Staff Summary Report

SUBJECT: Hold a public meeting for a Development Plan Review for **AGAVE CENTER – CARL’S JR. RESTAURANT** located at 8825 South Jewel Street.

DPR10007 -- Development Plan Review including site plan, building elevations and landscape plan.

DPR10007 CONDITIONS OF APPROVAL

LANDSCAPE PLAN

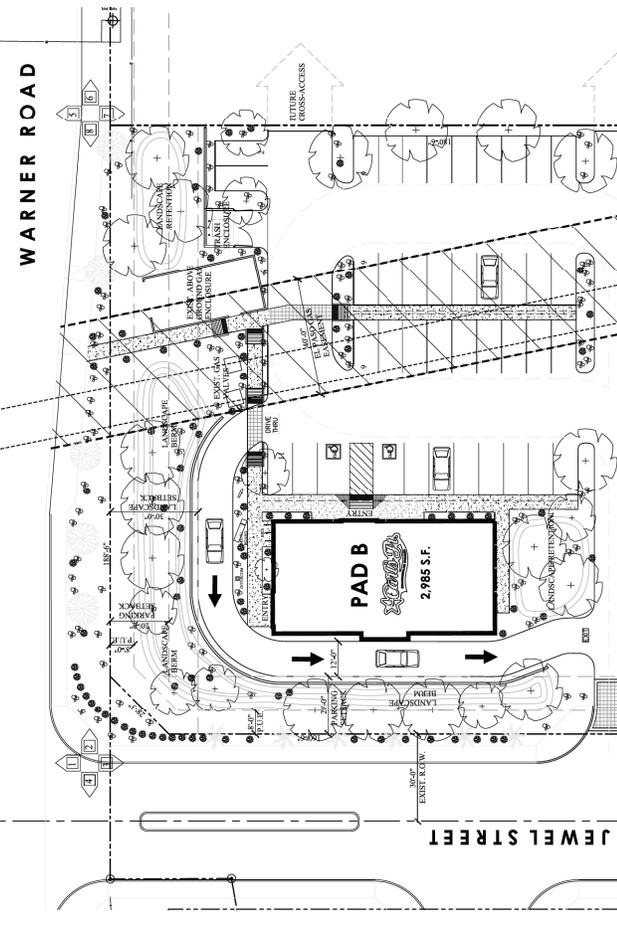
12. Provide a continuous 3'-0" high berm with a maximum 1:4 (rise to run) slope and provide a retaining wall for the berm along the front and street side of the drive-through. Measure the height of berm from the top of adjacent paving in the drive-through. Modify the topographic plan so the top of the berm rests on the retaining wall and does not slope down toward the wall.

13. Provide a continuous row of canopy trees (thirteen trees, not eleven as indicated) along the front and street side of the drive-through so there are no gaps in the tree row when the canopies mature, as indicated by modified condition of approval # 5 for VAR09018 AND VAR09019. Provide other trees where indicated on concept landscape plan. Provide trees of minimum 24" box size at installation. Where mesquites are included, provide a thornless cultivar.

14. Have a registered landscape architect prepare landscape and irrigation documents for construction. Survey the site, identify existing plant material by species and indicate existing plant material to remain on the landscape plan. Provide minimum 50 percent mature canopy coverage for all planting areas on site and in adjacent public right of way, except provide 100 percent mature canopy coverage in parking landscape islands (including those without trees) and planting areas at the base of the building. Increase variety in the plant materials schedule (one tree, palm, shrub and groundcover is inadequate).
